INDIANA DEPARTMENT OF ENVIRONMENTAL MANAGEMENT

Re: Long Term Control Plan Amendment Review
City of Terre Haute
NPDES Permit No. IN0025607
State Judicial Order No. 84D02-0809-CC-11402
Vigo County

The Indiana Department of Environmental Management (IDEM) Office of Water Quality (OWQ) has conducted a substantive review of the City of Terre Haute's Combined Sewer Overflow (CSO) Long Term Control Plan (LTCP) Amendment originally submitted January 22, 2014, with the final revision submitted September 18, 2014. The original LTCP was approved on August 10, 2011.

Figure ES-2
Recommended Plan
REVISED - SEPTEMBER 2014

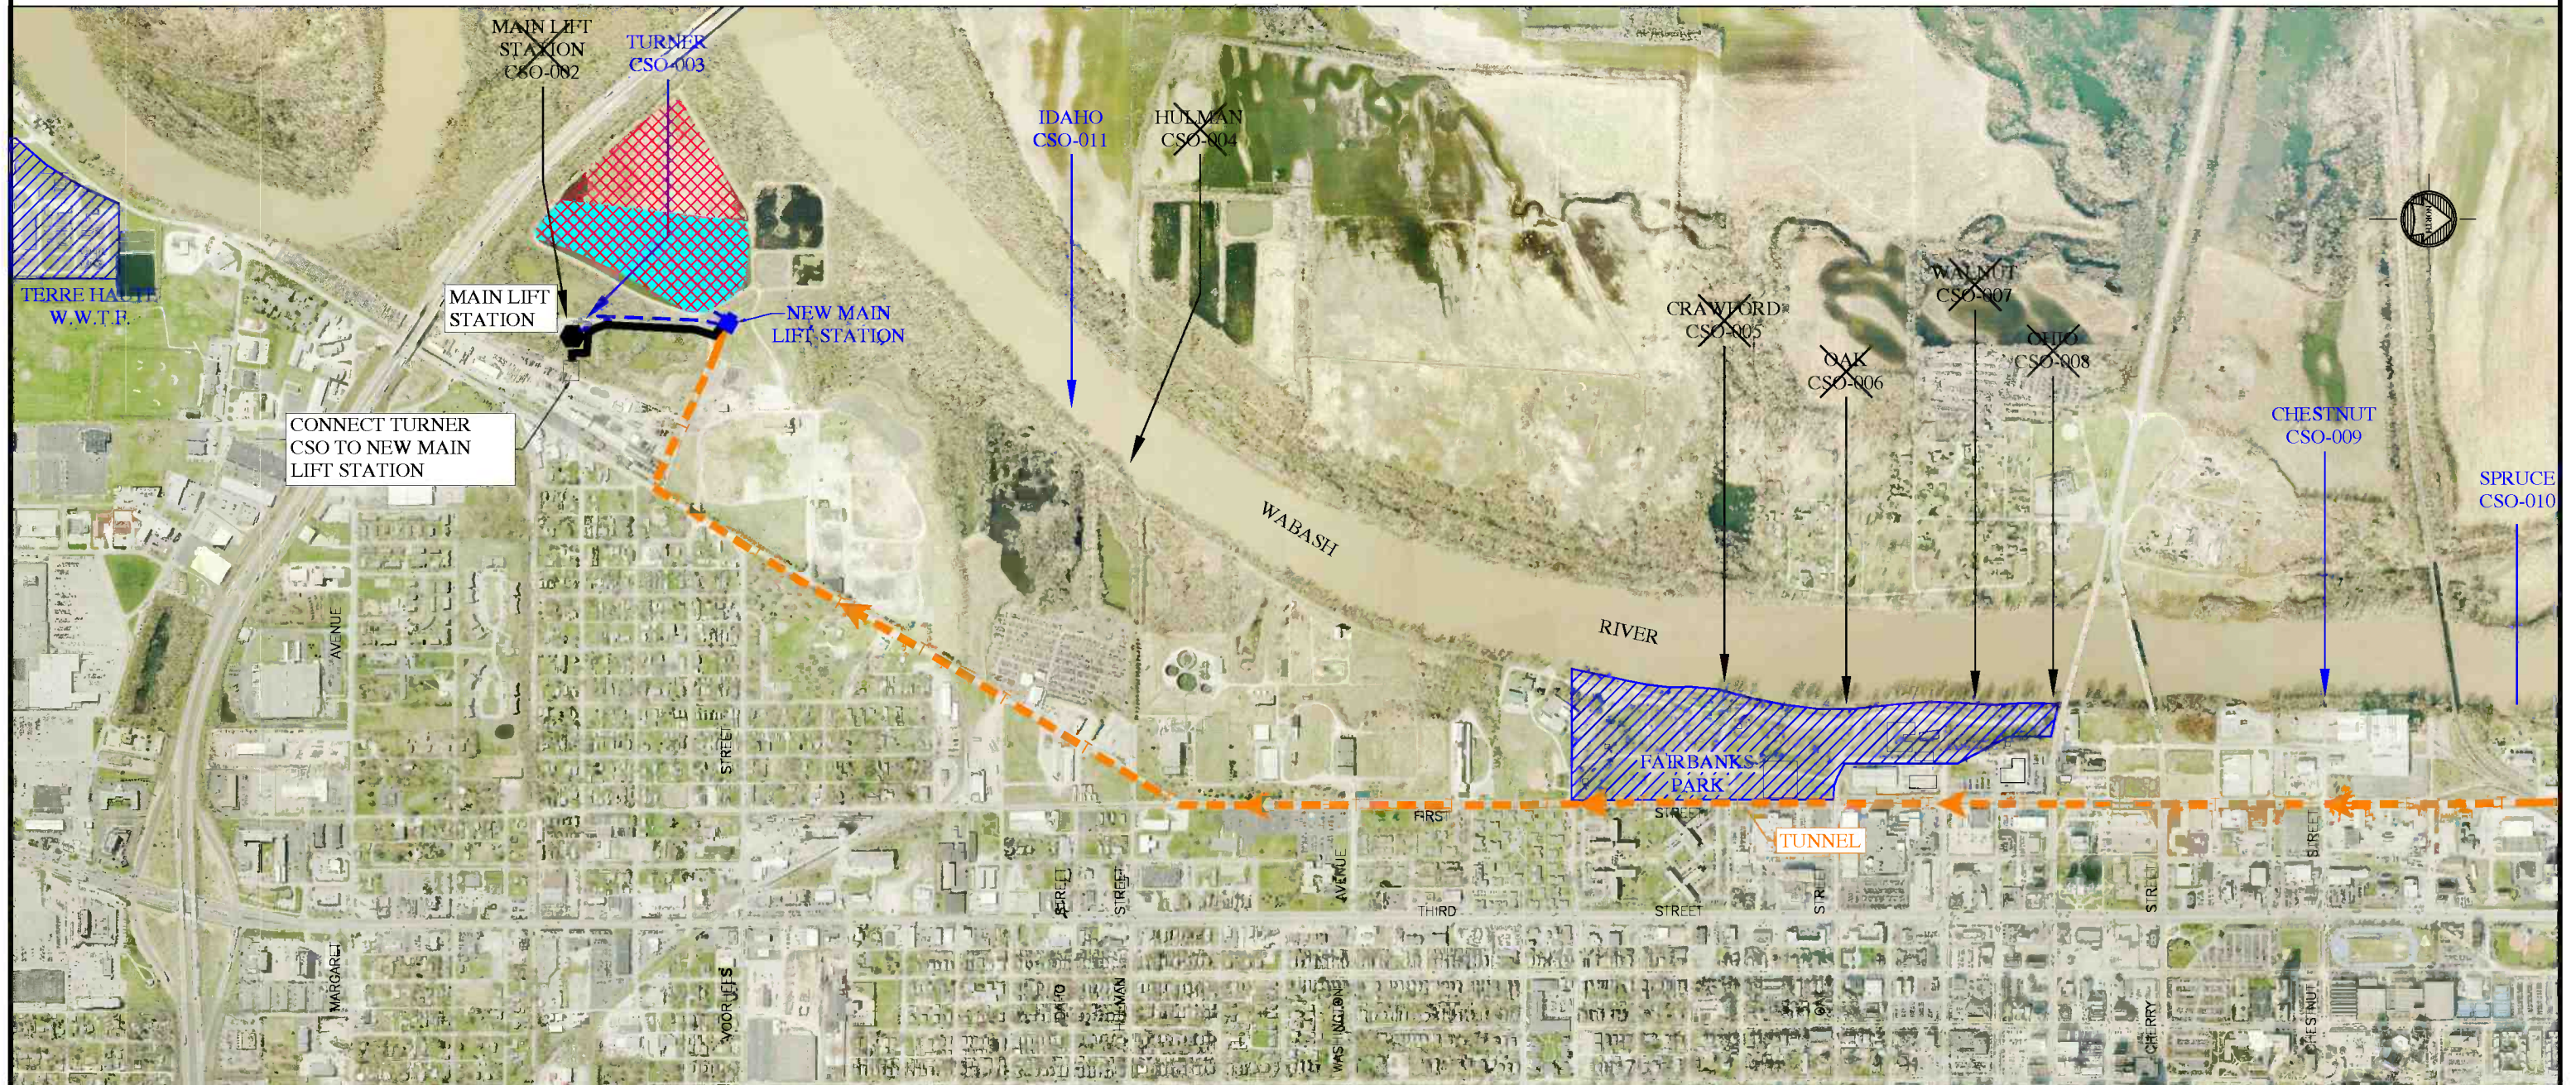
- 2) Section 6.8.1.4 (Page 6-52) – It states that outfalls 004, 005, 006, 007, 008, 009 and Turner (003) will be closed. Maps in Figures ES-2, 6.7-4 and 10.2-1 show Turner will remain open. Why do the maps show CSO 003 to remain open? If CSO 003 is to remain open, why can it not be closed? Also, there is no mention in this section that CSO 002 will be closed, but the maps indicate CSO 002 will be eliminated. Please clarify the fate of CSOs 003 and 002.

- 1) The maps in Figures ES-2 (Recommended Plan), Figure 6.7-4 (Alternative 11b), Figure 10.2-1 (Recommended Plan) and 10.3-1 (Phasing of Recommended Plan) are all slightly different. Which map contains the accurate depiction of the recommended plan? Please update the maps that are inaccurate.

Figure 6.8-2
ALTERNATIVE 11
REVISED - SEPTEMBER 2014

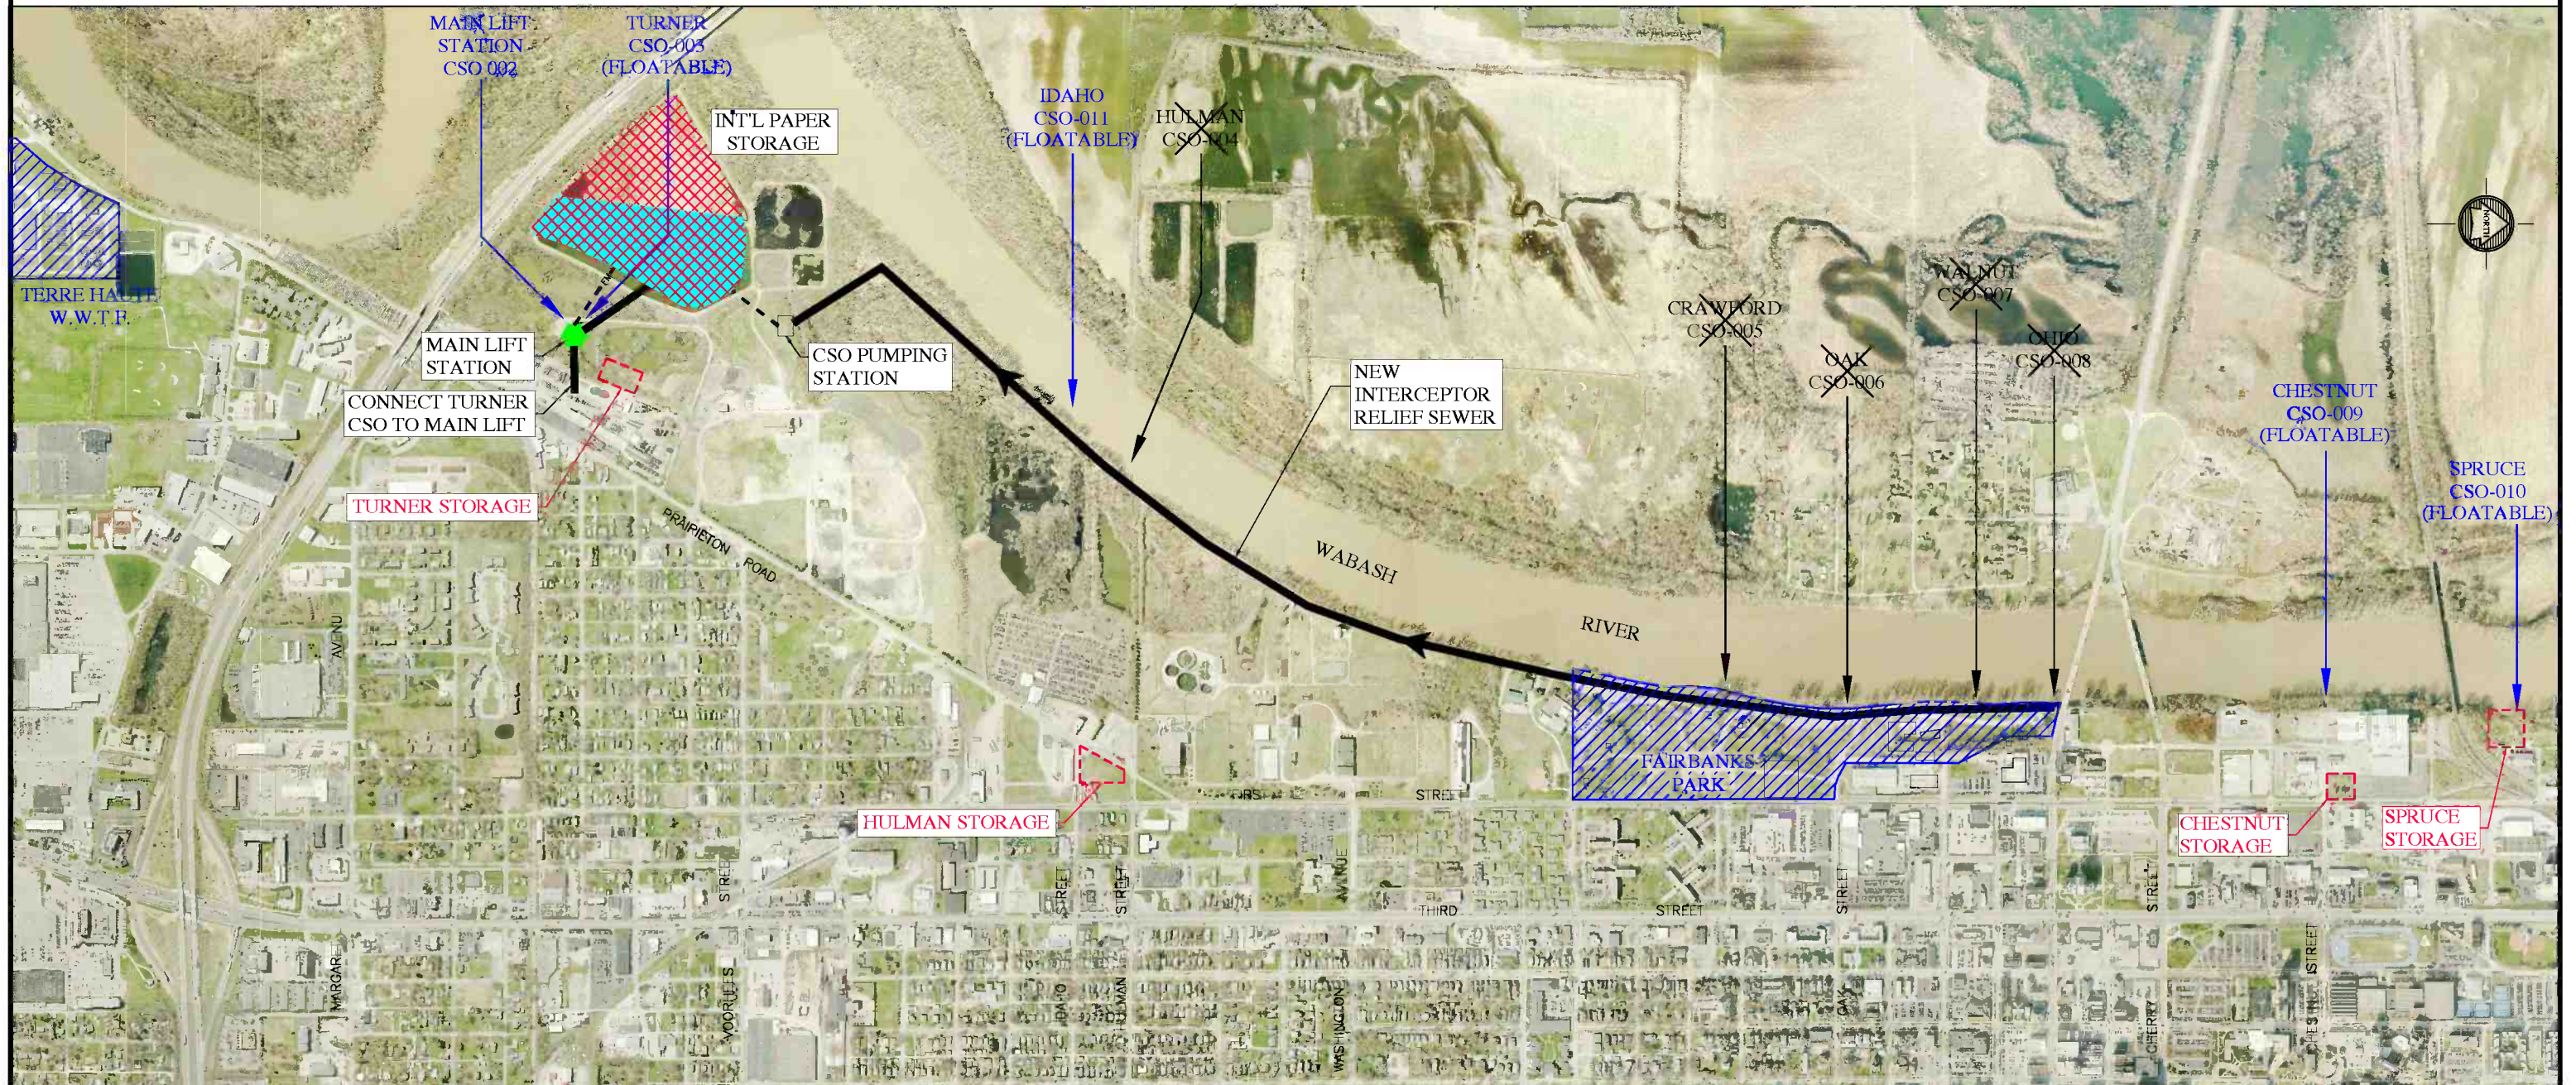
- 2) A revised map of Alternative 11 in Figure 6.7-2 was submitted. The map for Alternative 11 does not reference the storage lagoons at the IP site which is a project in Alternative 11, but rather shows the new high rate treatment facility which is a project in Alternative 11b. It appears in the LTCP Amendment that Alternative 11 has not changed. Why was a revised map of Alternative 11 submitted?

Figure 6.7-2 (now titled 6.8-2) has been revised so that it shows only those project elements included in Alternative 11.

Figure 10.2-1
Recommended Plan

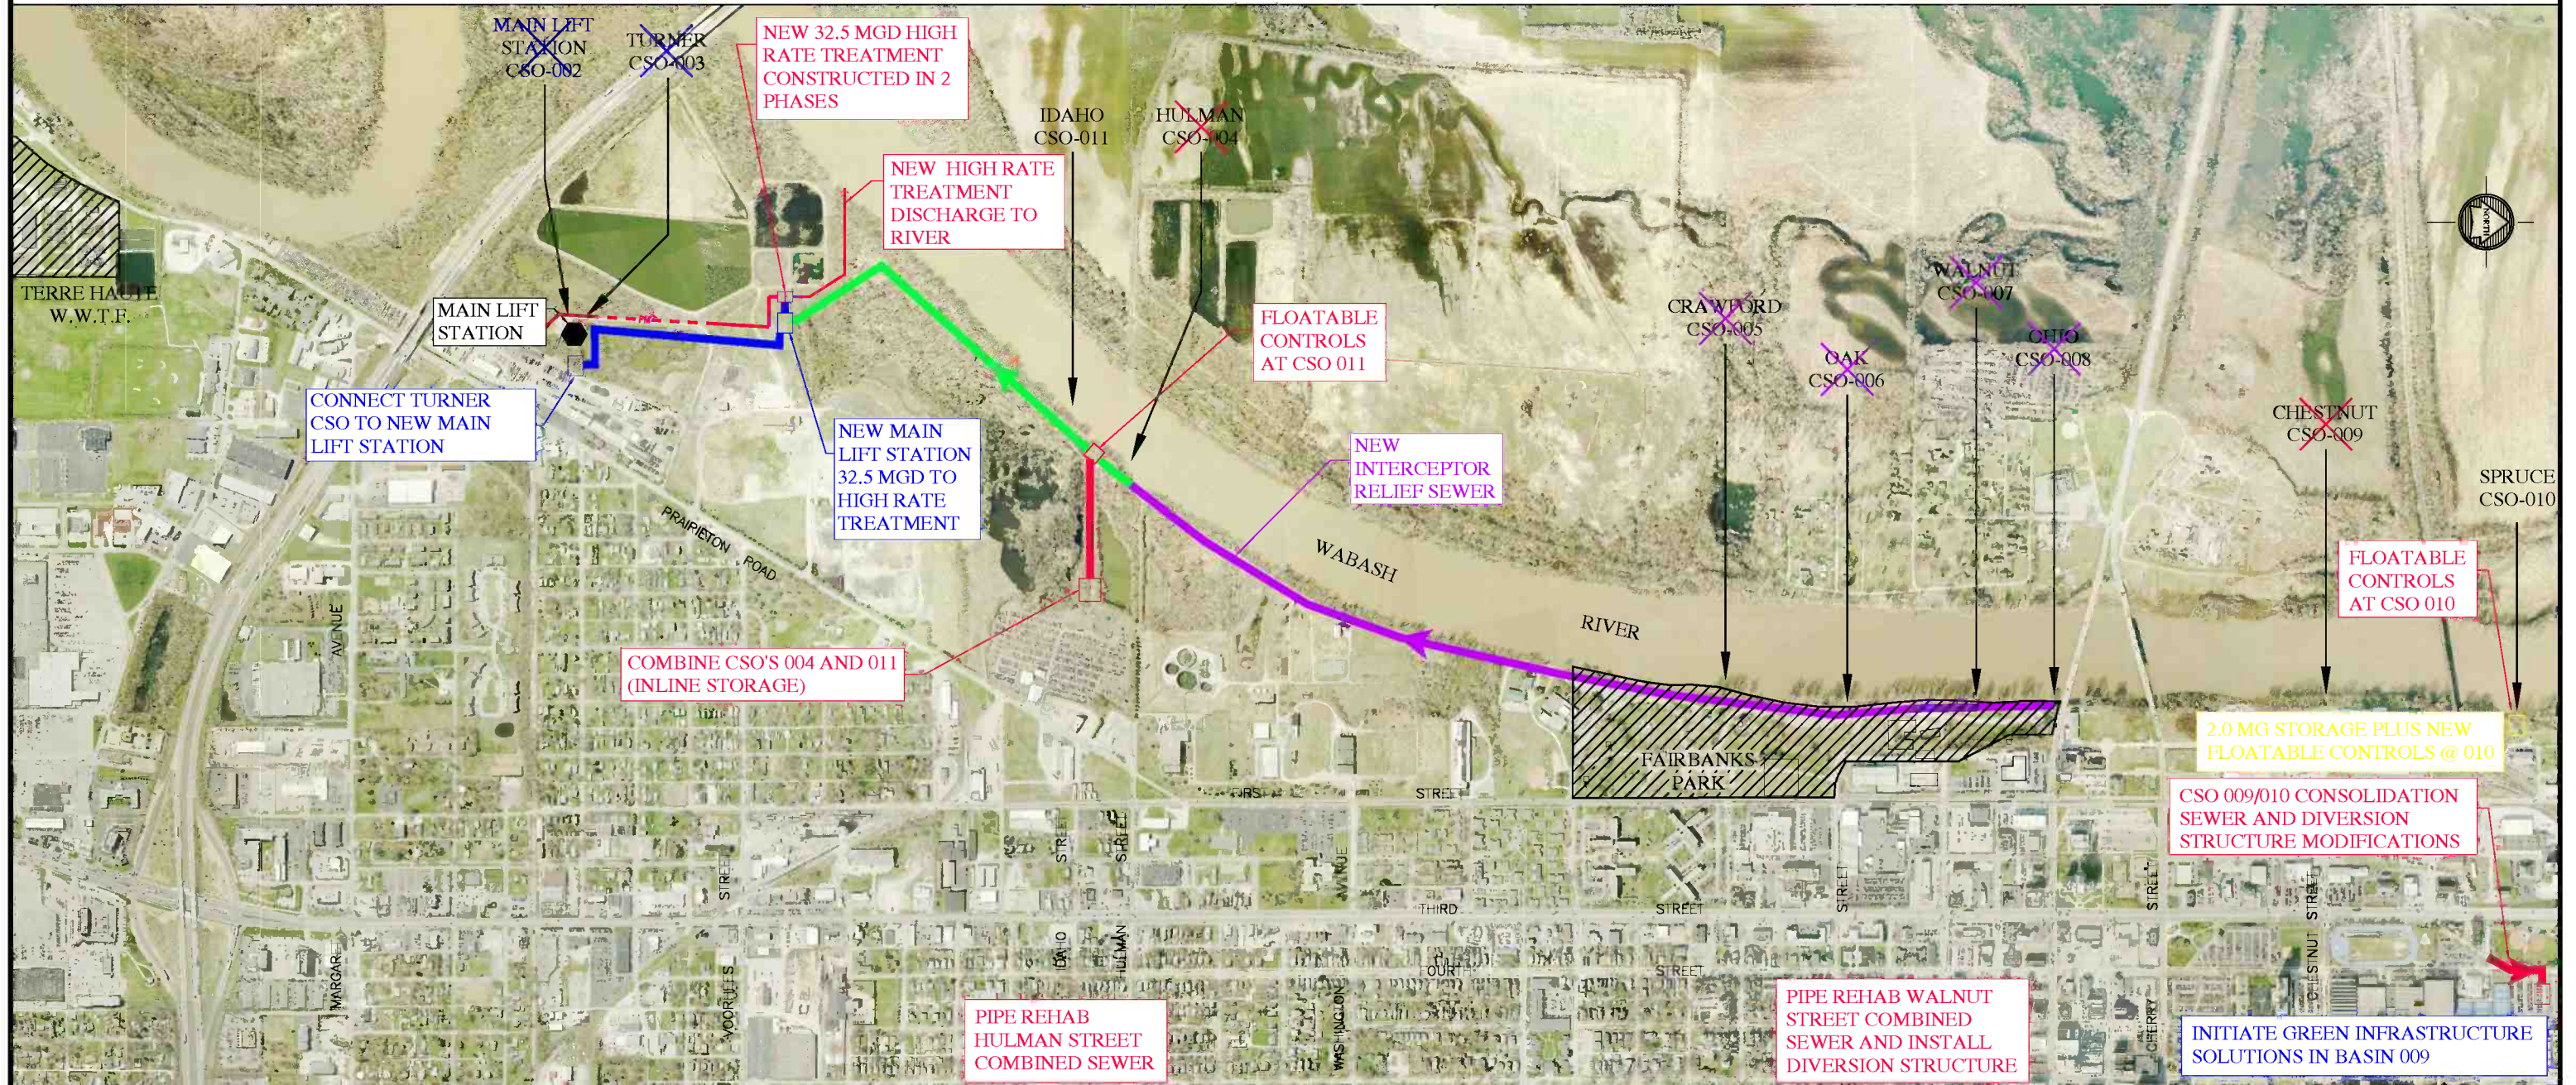
- 5) Section 10.2 (Page 10-4) – Figure 10-2013-2 is referenced. Is the figure titled correctly within the text?

- 6) Section 10.2 (Page 10-6) – Figure 10-2013-1 is referenced. Is the figure titled correctly within the text?

The figure was not titled correctly within the text. The figure referenced should be Figure 10.2-1. The report has been revised accordingly.

The figure was not titled correctly within the text. The figure referenced should be Figure 10.2-1. The report has been revised accordingly. Furthermore, the text has been revised so that the previous CSO 009 to CSO 010 consolidation sewer location is no longer included.
